ADDENDUM NO. 3

**CITY OF HIALEAH
HEA CHARTER SCHOOL EXPANSION
2590 W 76TH ST
HIALEAH, FLORIDA**

The original Contract Documents, for the Project entitled **CITY OF HIALEAH – HEA CHARTER SCHOOL EXPANSION-GENERAL CONTRACTOR-BID# 2014/15-3230-00-011** is hereby amended as noted in this **Addendum No. 3**.

SKT-1 ADD #3

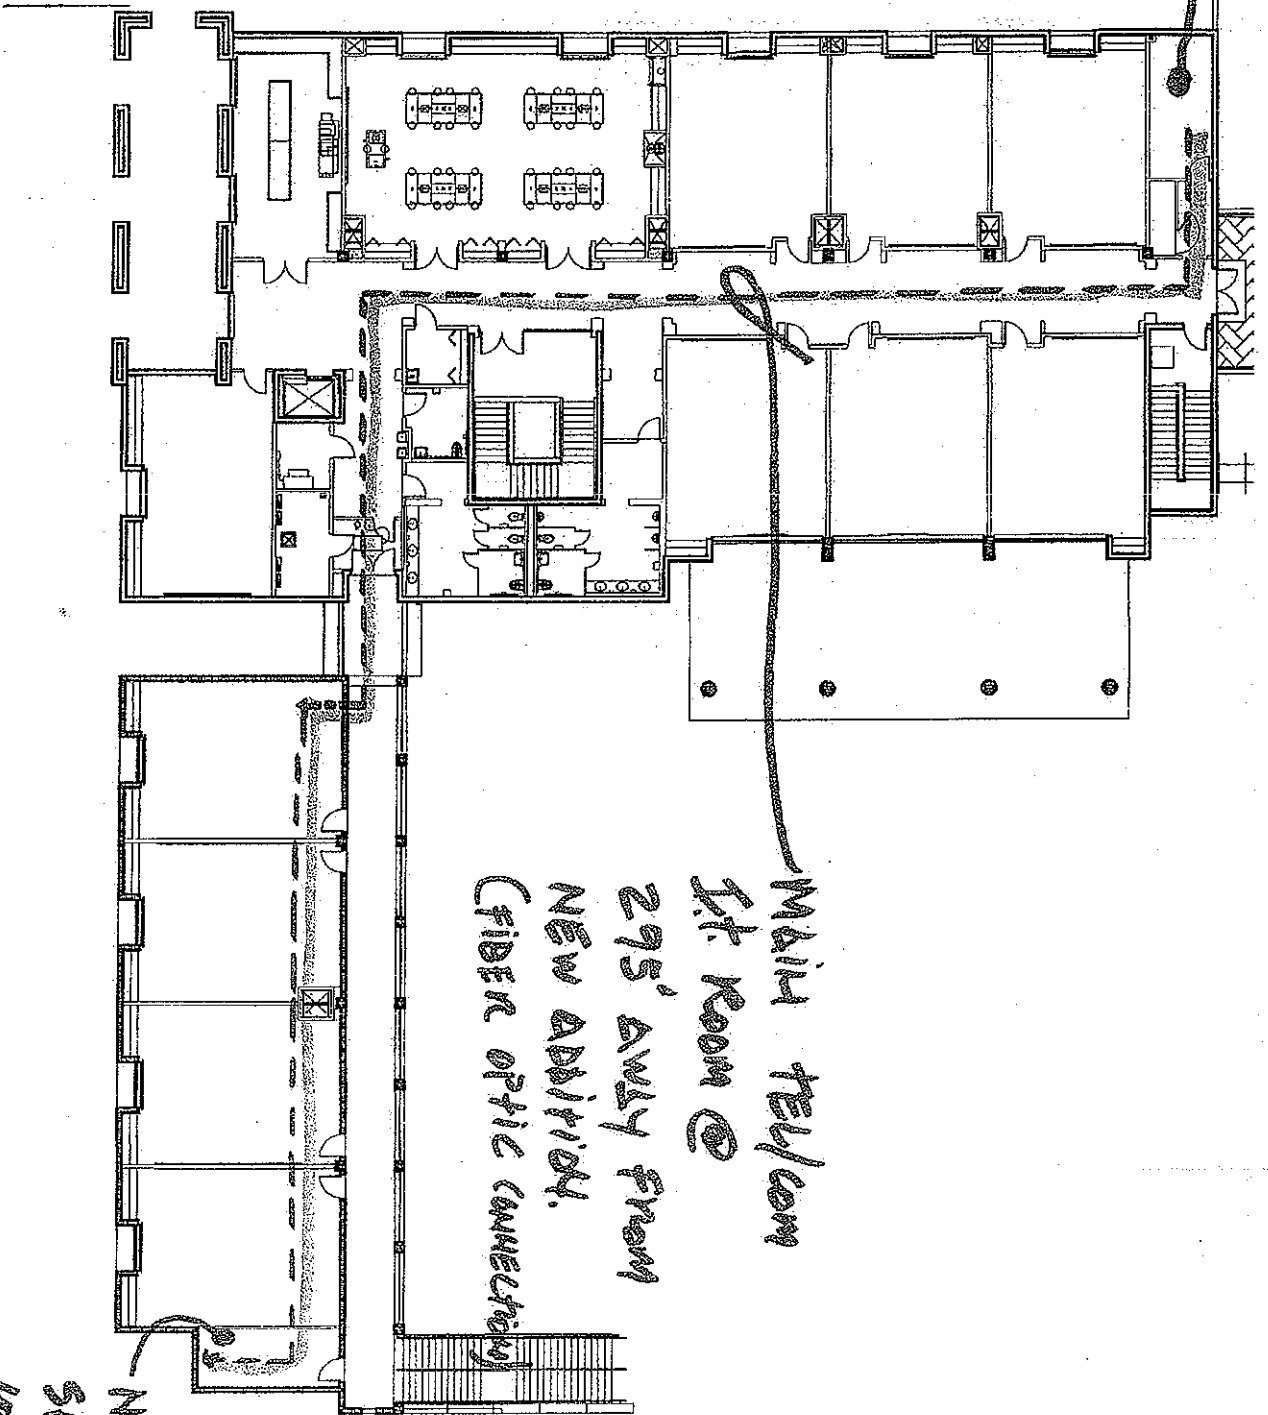
1. Please provide the distance of the nearest Telecom Room at existing building, floor plans do not indicate. Or shall new building have its own Telecom Room?

Please note that the new addition will have a point of secondary servers located at the end of office room No. 245, (located on the 2nd floor). From this point, the servers will connect to the new data-drop locations at the new classrooms. (The server-equipment is to be provided by the school).

Please note that the existing Tele-communication room that serves the school information and data system is located on the 2nd level of the school. (PLEASE SEE ATTACHED SKETCHES)

It is at an approximate distance of 295' way from the new server's location (this is a horizontal distance estimate and does account for any vertical changes, please account for such additional distances and curved corners as required).

Due to the distance between the existing Tele/Com room and the new servers, these shall be connected by a fiber optic cable. Please provide pass-through metal conduit(s) at bridge location, (between existing and new building) specific conduits shall include but not be limited to Fiber Optic, Fire Alarm connection, burglary connection, etc. Underground connections shall also be approved.
